TB2001

## TRACTOR SERVICE INFO

Part Nr. 333 0170 11 – 330mm TDCA – 17 Spline

Info: 333 0170 11 replaces / ersetzt / remplace / sustituye a / sostituisce 333 0136 10 and 333 0170 10

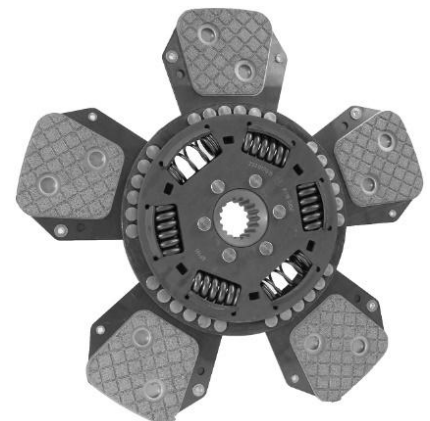
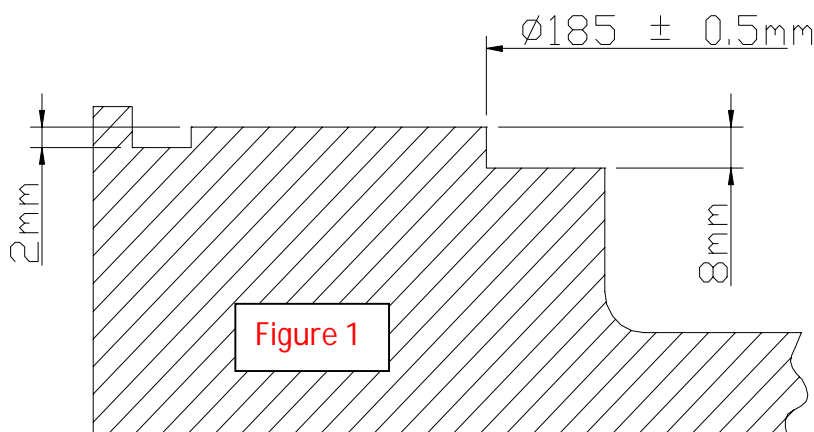
Re-machine the flywheel inner recess to a diameter of  $185 \pm 0.5$  mm and a depth of 8 mm to avoid rivet contacting flywheel.

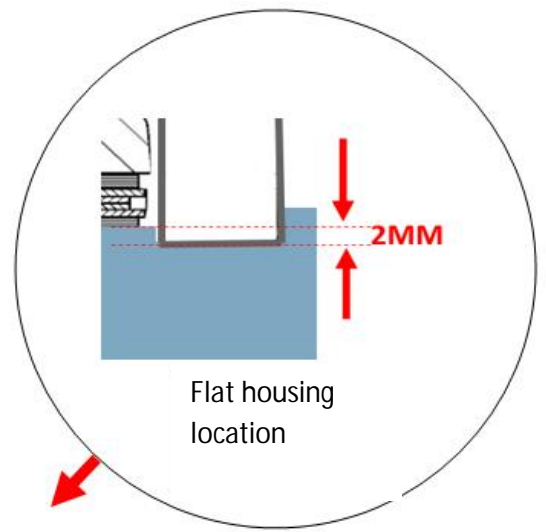
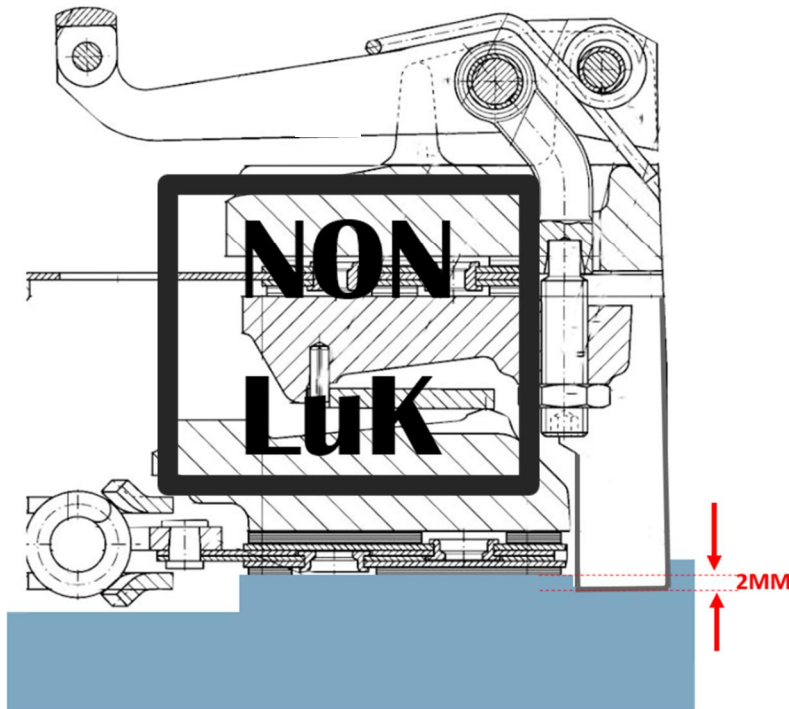
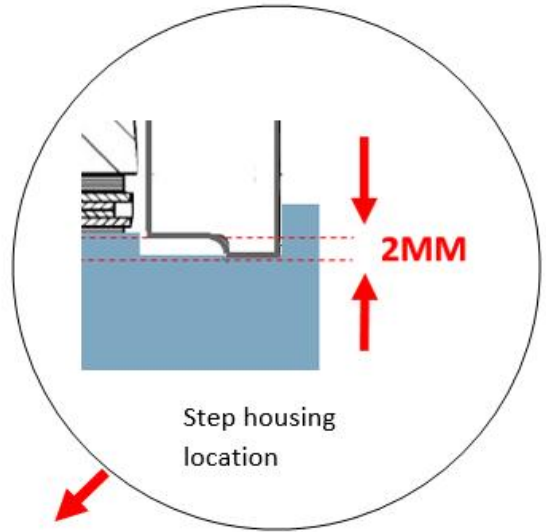
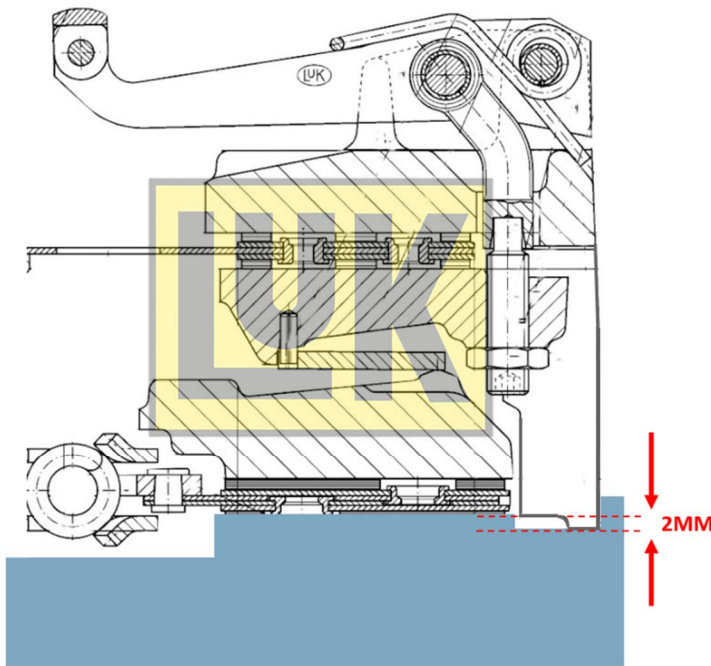
**Clutch housing location using flywheel step of 2mm. See Figure 1**
